| FDI | ENGINEERING CHANGE ORDER | | | ECO NO: 18-005 | |
| uEZGUI-4357-50WVN-BA | AUG4350VNBA14 | 1.4 | AUG4350VNBA20 | 2.0 | |
| uEZGUI-4357-50WVN | AUG4350VN14 | 1.5 | AUG4350VN20 | 2.0 | |

BACKGROUND:

LCD Connector J9

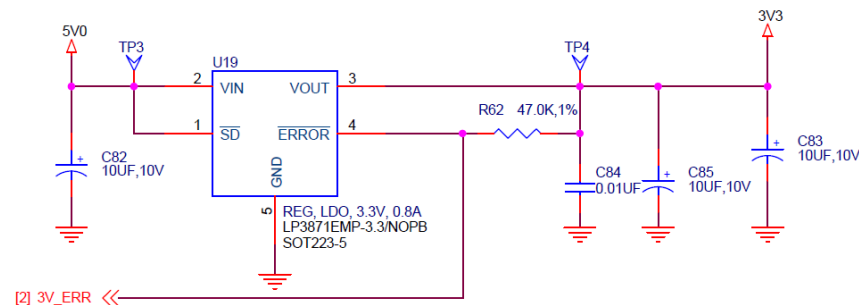
- Move 4WRTP signals from ADC-only pins (U1 pin B3 & A5) to pins supporting GPIO & ADC function (U1 pin D6 & B7)

J9 pin 38 to U1 pin D6 - GPIO7.23/ADC1.2

J9 pin 39 to U1 pin B7 - GPIO7.21/ADC1.7

OLD DCDC

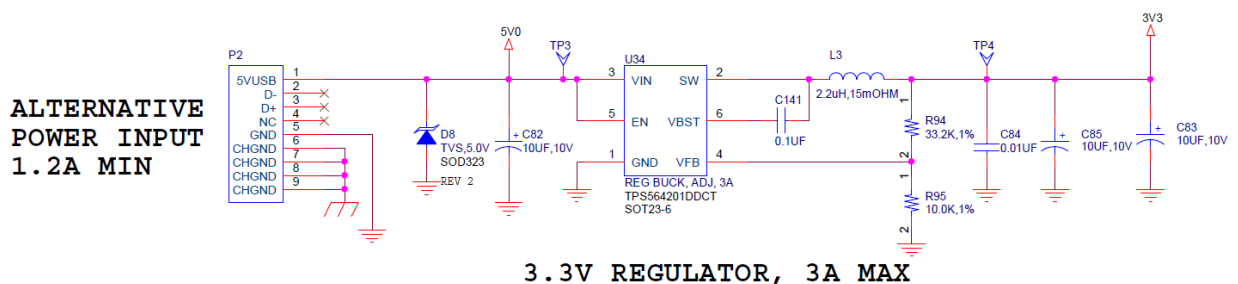
- Change 3.3V DCDC from LDO to high-capacity switching DCDC IC;
Remove U19 LP3871 U500385 and R62 47.0K R500524, delete '3V_ERR' signal

Add U34 TPS564201 U500678, C141 C500234, L3 L500092, R94 R500748, R95 R500060, & D8 D500190

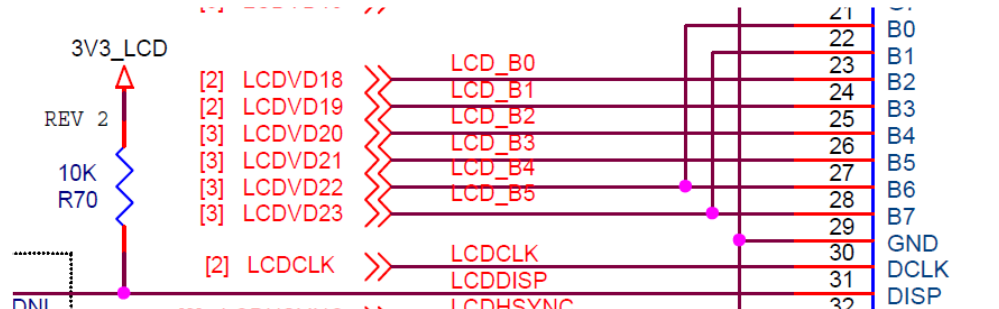
- Add 5V DC input via dedicated USB Mini-B Connector, P2, FDI PN: J500027

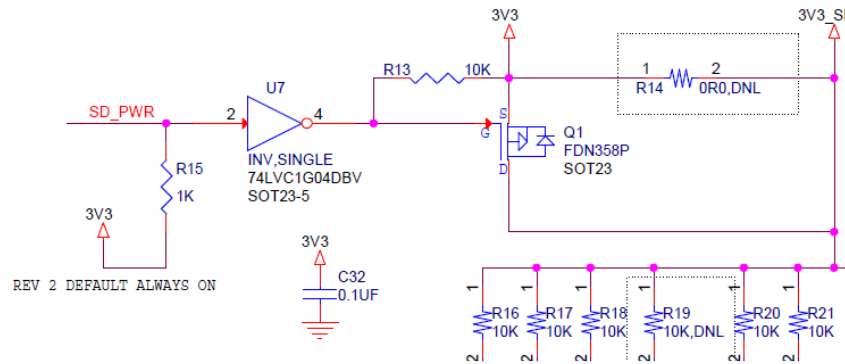
- Add 10K ohm pullup R70 R500459 to LCD DISP signal, J9 pin 31

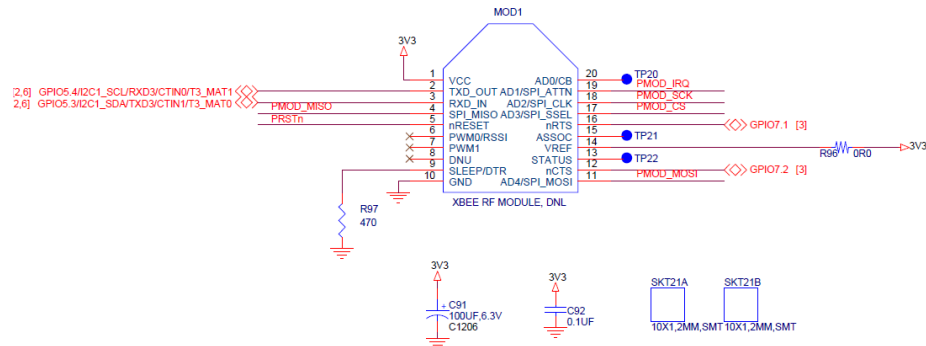
- Change SD socket power switch to default to always – change R15 from pull down to pullup;

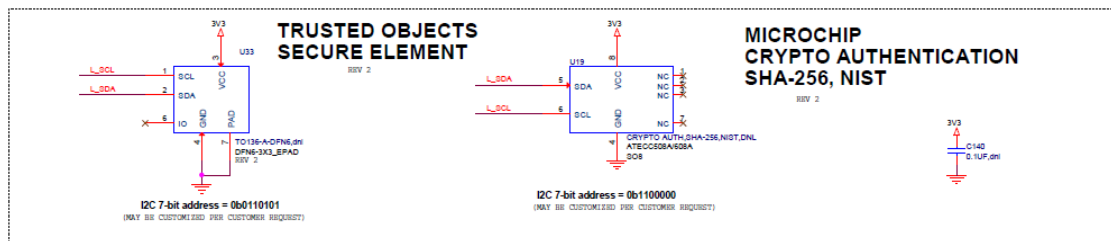
- Add XBee socket for optional wireless modules, SKT21A SK50010, SKT21B SK50010, C91 C500284, C92 C500234, R97 R500469, & R96 R500436 – no module is loaded

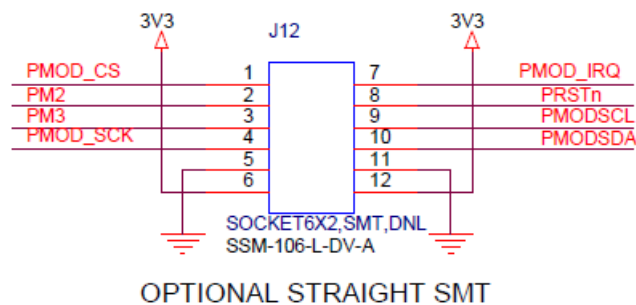
- Add optional security ICs, U33 Trusted Objects TO136 U500691 DNL, U19 Microchip ATECC608A U500706 DNL, & C140 C500234

Pmod CONNECTOR (DEFAULT SPI TYPE 2A)

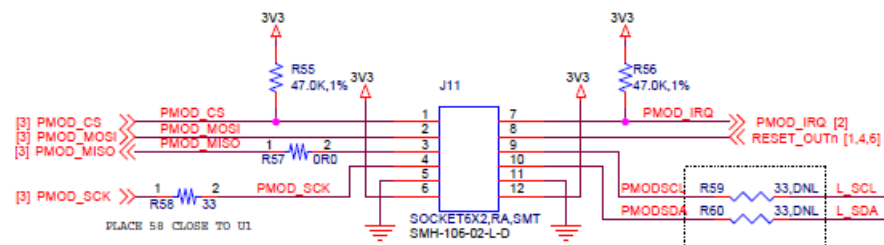
- Add SPI/UART zero ohm resistor configuration (on J11 pin 2 & 3) and GPIO controlled capability to generate Peripheral Reset signal (J11 pin 8) to Pmod – connect PERIPH_RSTn to MCU U1 pin P14, GPIO7.0. In addition, update the Pmod schematic symbol to illustrate the pin functions.

Add U4 74LVC1G08 U500382, C93 0.1uf C500234, R71 33ohm R500461
Change R58 from 33ohm R500461 to Zero ohm R500436

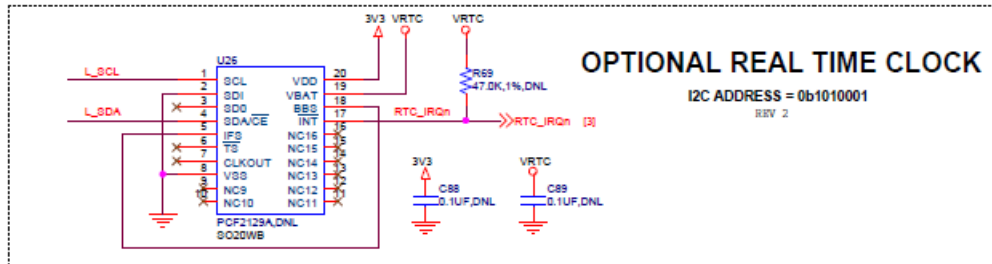
- Add optional I2C Low Power, High accuracy Real Time Clock – U26 NXP PCF2125A U500438, R69 R500524, C88 C500234, C89 C500234, all DNL

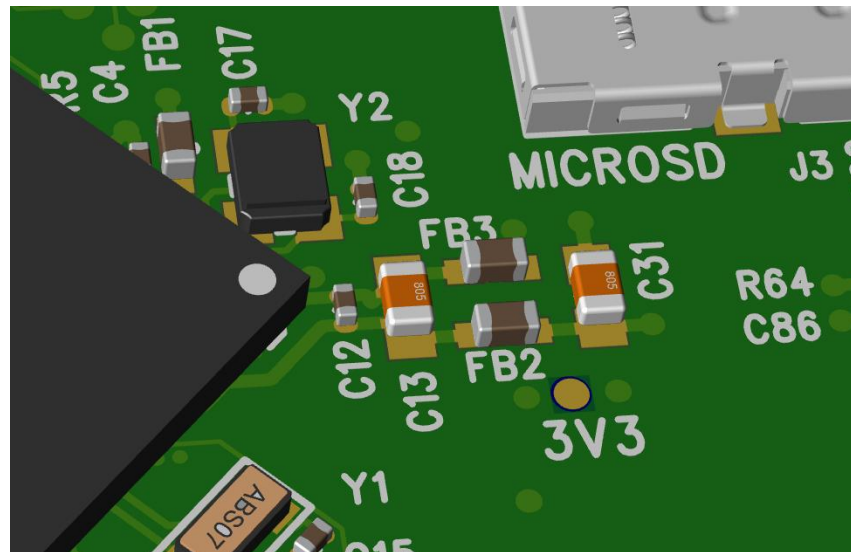
- Shift MCU analog supply components (C12, C13, FB2, FB3, & C31) away from MCU to clear BGA package overhang – change C12 C500234 to LOAD
